MS9446  
AMENDMENT 1  
8 JULY 2003

BOLT, MACHINE - STEEL AMS 6304, DIFFUSED NICKEL-CADMIUM PLATED,  
HEXAGON HEAD, DRILLED, .5625-18 UNJF-3A

This amendment forms a part of MS9446, dated 21 December 1962, and is approved for use by all Departments and Agencies of the Department of Defense.

## Sheet 1

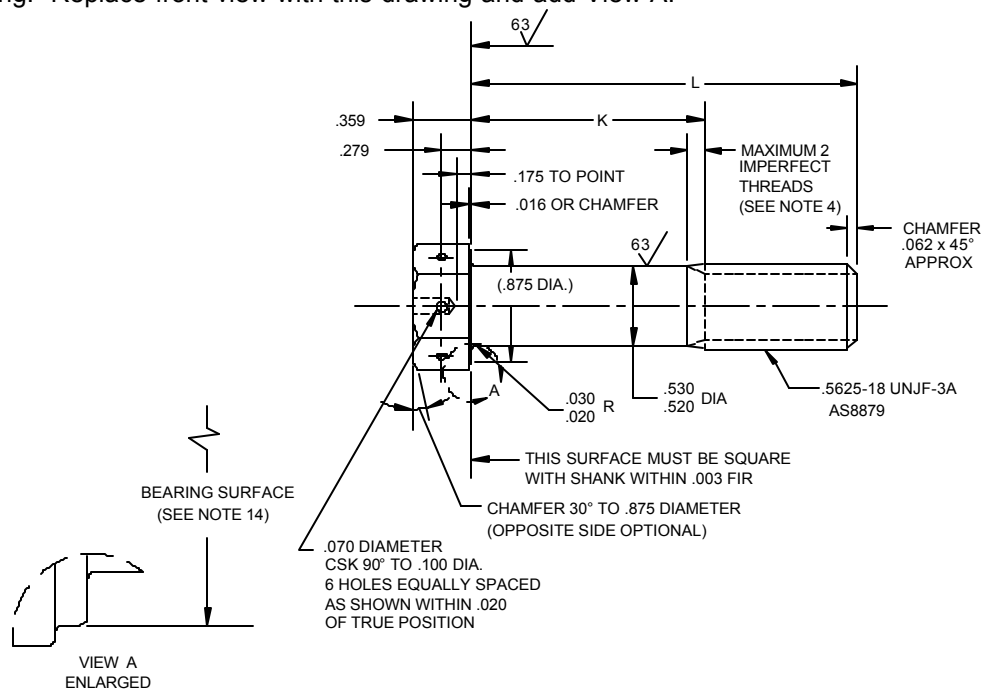
In drawing: Replace front view with this drawing and add View A.
